FIRE SAFETY INSPECTION REPORT

RATUL FABRICS LTD

ACCORD
on Fire and Building Safety in Bangladesh

April 19, 2015

F-6 Egress

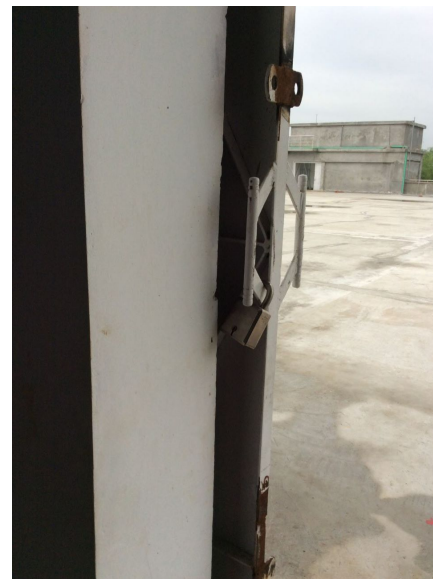
Building did not have stair designation signs at exit stairs. Building did not have occupant load signs at factory floors.

Provide stair designation signs and occupant load signs at required locations.

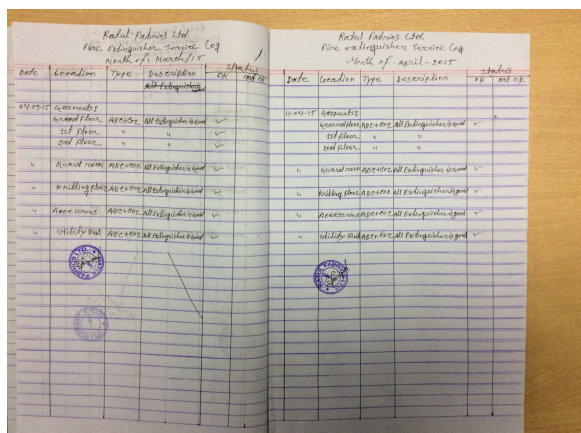
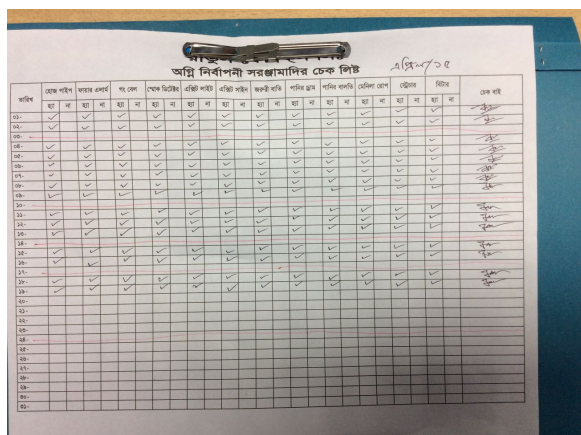
F-14	Fire Protection	Inspection, testing and maintenance of portable fire extinguishers is not in accordance with NFPA 10.	Inspect, test and maintain the portable fire extinguishers and keep written records on-site, in accordance with NFPA 10.	Within 3 months
------	-----------------	---	--	-----------------

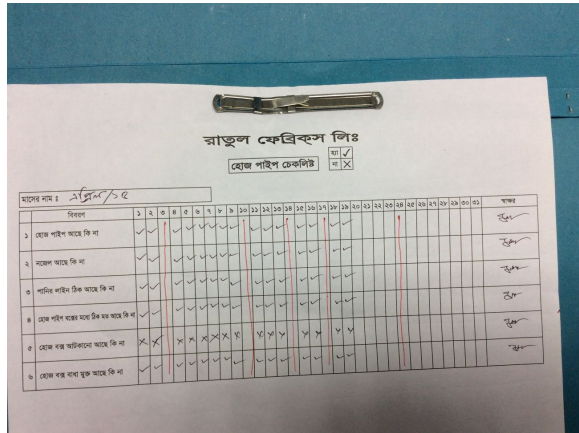
F-17	Fire Protection	Inspection, testing and maintenance of the standpipe system is not in accordance with NFPA 14.	Inspect, test and maintain the standpipe system and keep written records on-site, in accordance with NFPA 14.	Within 3 months
------	-----------------	--	---	-----------------

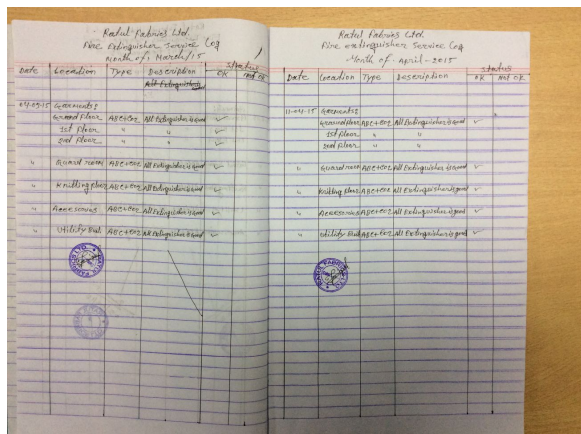
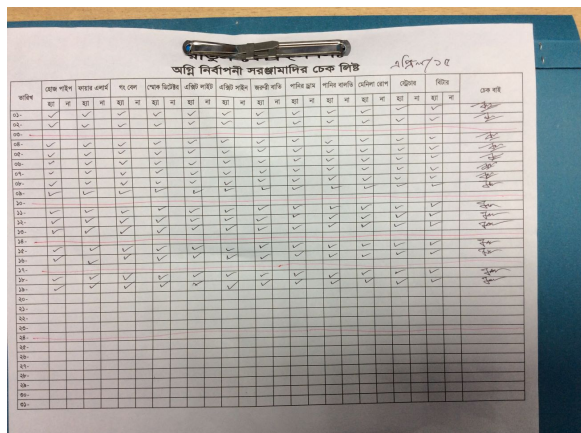
F-10	Fire Protection	Inspection, testing and maintenance of portable fire extinguishers is not in accordance with NFPA 10.	Inspect, test and maintain the portable fire extinguishers and keep written records on-site, in accordance with NFPA 10.	Within 3 months
------	-----------------	---	--	-----------------

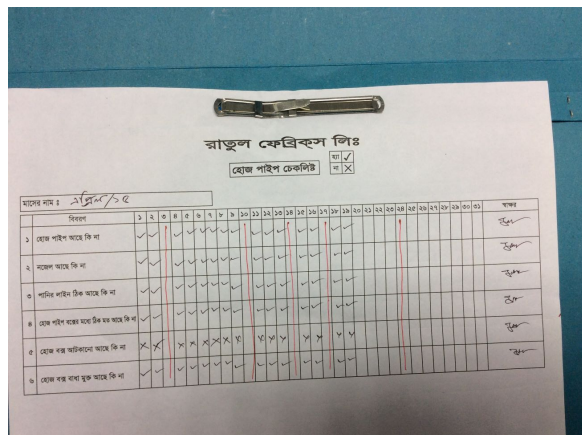
F-13	Fire Protection	Inspection, testing and maintenance of the standpipe system is not in accordance with NFPA 14.	Inspect, test and maintain the standpipe system and keep written records on-site, in accordance with NFPA 14.	Within 3 months
------	-----------------	--	---	-----------------
